ENGINE SYSTEMS, INC.

Report No. 10CFR21-0090
Rev. 0: 09/16/05

10CFR21 REPORTING OF DEFECTS AND NON-COMPLIANCE

COMPONENT: Governor Drive Coupling Element
P/N AK-007-001

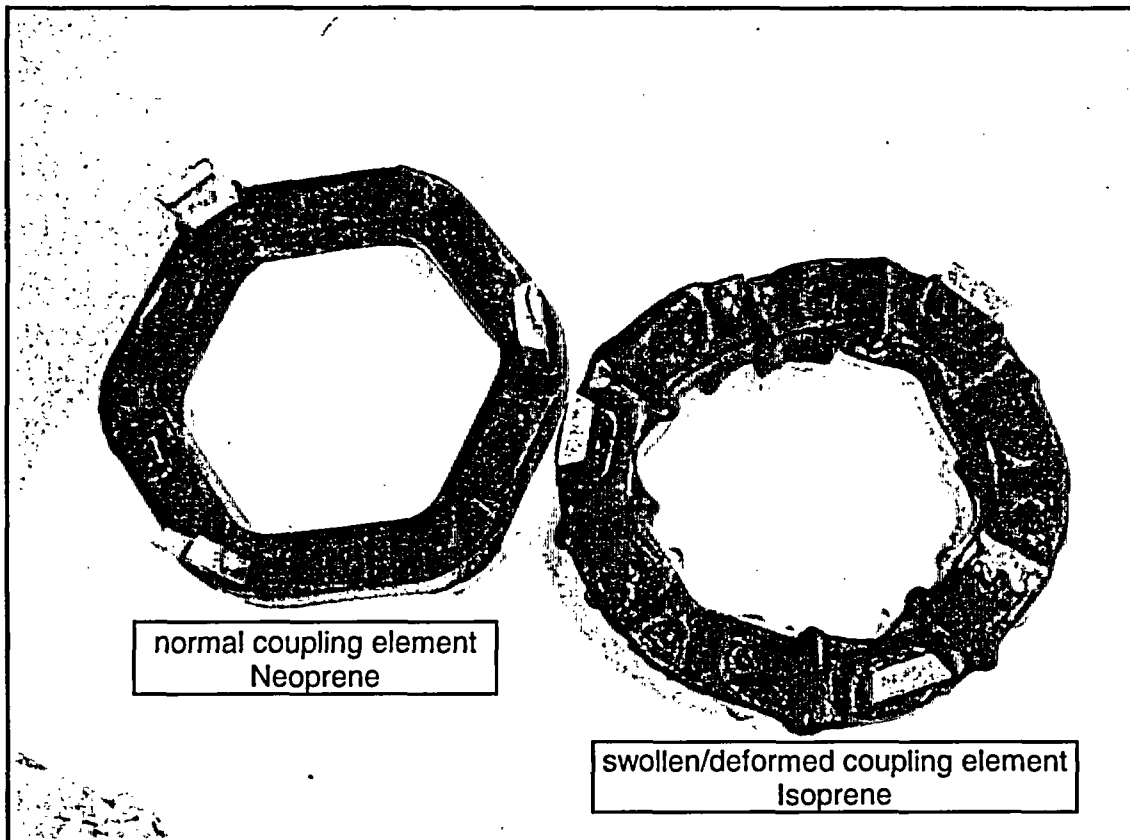
In June 2005, the Shearon Harris plant had reportedly removed a coupling element from their diesel engine and observed the material to be swollen and deformed (see Figure 1 below). A subsequent technical report provided by the site's Materials Services Section found the material composition of the element to be isoprene (natural rubber). The current design of the coupling specifies the material to be polychloroprene (neoprene).

The results of ESI's internal investigation revealed that several utilities have been supplied coupling elements made from isoprene. The isoprene material is not suitable for the high temperature, oil rich environment of the engine gear case and is susceptible to failure after prolonged exposure (the condition reported at Shearon Harris was noted after being installed on the engine for 16 months).

1. Review their inventory for suspect elements listed in Table 1. Any suspect elements should be removed from inventory and replaced.
2. Determine if suspect elements listed in Table 1 have been installed on the engine. ESI has not been able to determine an expected service life of isoprene coupling elements when exposed to the high temperature, oil rich environment of the engine gear case. Therefore, our recommendation is to replace any installed suspect elements as soon as possible.
